Strategic Housing Development – Statement of Response to the Notice of Pre-Application Consultation Opinion

Regal Park Developments Limited
Walkers Lane, Annacotty, Limerick

March 2020

Title:	Strategic Housing Development – Statement of Response to the Notice of Pre-Application Consultation Opinion	
Project:	18034 Parkes Residential Development Annacotty	
Prepared by:		
Signed:		Approved by: Mary Hughes (Director)
Date:	March 2020	
Issue:	Final 01	
<p>© Copyright HRA PLANNING. All rights reserved. This report has been prepared for the exclusive use of the commissioning party and unless otherwise agreed in writing by HRA Planning, no other party may copy, reproduce, distribute, make use of, or rely on the contents of the report. No liability is accepted by HRA PLANNING for any use of this report, other than for the purposes for which it was originally prepared and provided. Opinions and information provided in this report are on the bases of HRA PLANNING using due skill, care and diligence in the preparation of the same and no explicit warranty is provided as to their accuracy. It should be noted and is expressly stated that no independent verification of any of the documents or

Figure 4.0 Location of Childcare Facilities

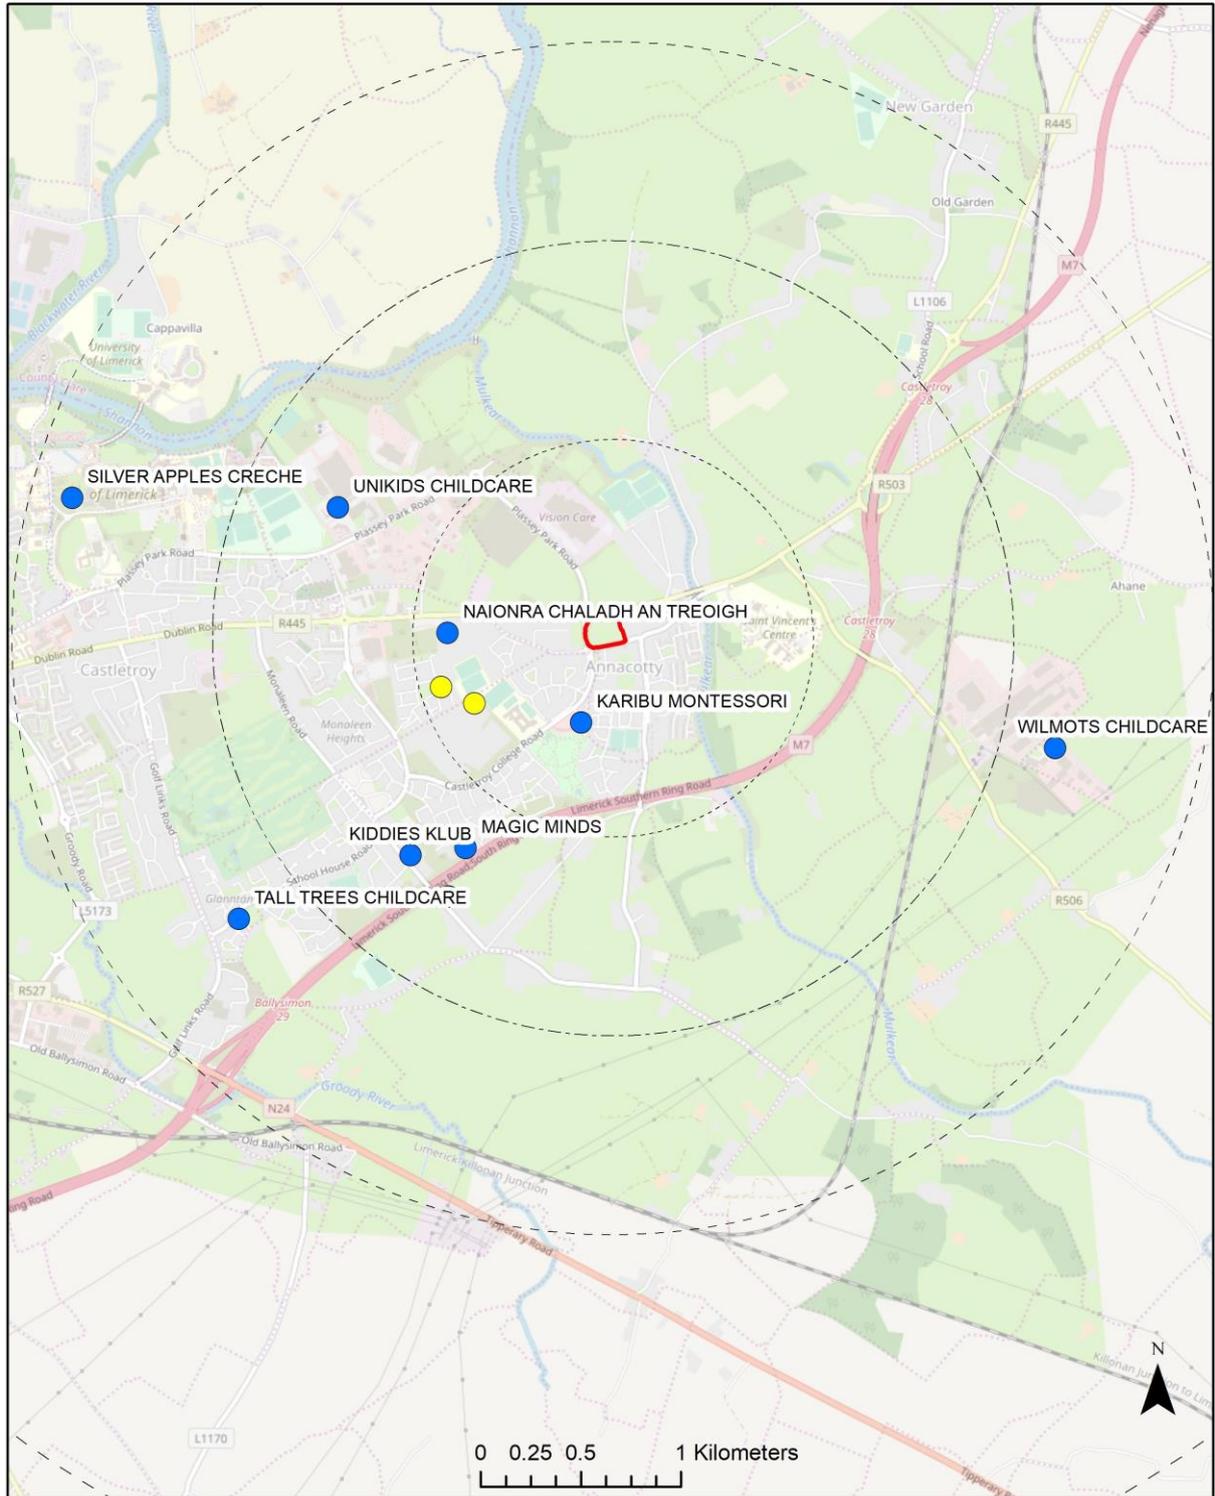
The proposal at pre planning stage provided for a creche facility with capacity for 50 no. children. The need, scale and location of the creche facility was questioned at the pre planning meeting.

There are 8 no. creches, as identified in Figure 4.0, which are located within a 3km radius of the site – a reasonable distance of the application site having regard to employment and educational locations in the surrounding area. These 8 no. creches were contacted by phone in September 2019 (beginning of school year) to establish their capacity. In some instances, the information was not secured from the operators, due to perceived commercial sensitivity and therefore TUSLA reports, which represent a snapshot in time were relied upon in such instances. Table 2.0 below provides an overview of capacities within existing creche facilities.

Further it should be noted that planning permission has been secured for an addition 2 no. creche's within 1km of the subject site, identified in yellow in Figure 4.0. Cumulatively these new creche facilities will provide capacity for an additional 288 no. children (P19/547 – 181 child creche & P19/492 – 107 child creche). Whilst these creche's are intended to accommodate existing and future residential development in the area, they nonetheless provide additional capacity in a fluid childcare market.

Having regard to the above analysis, it is not proposed to provide for a childcare facility as part of the proposed development. However, if the Board is minded to disagree and to require such a facility irrespective of the foregoing assessment, it is confirmed that the single storey communal facility attached to Apartment Block A to the north, could easily be amended to accommodate a childcare facility capable of accommodating 34 no. children.
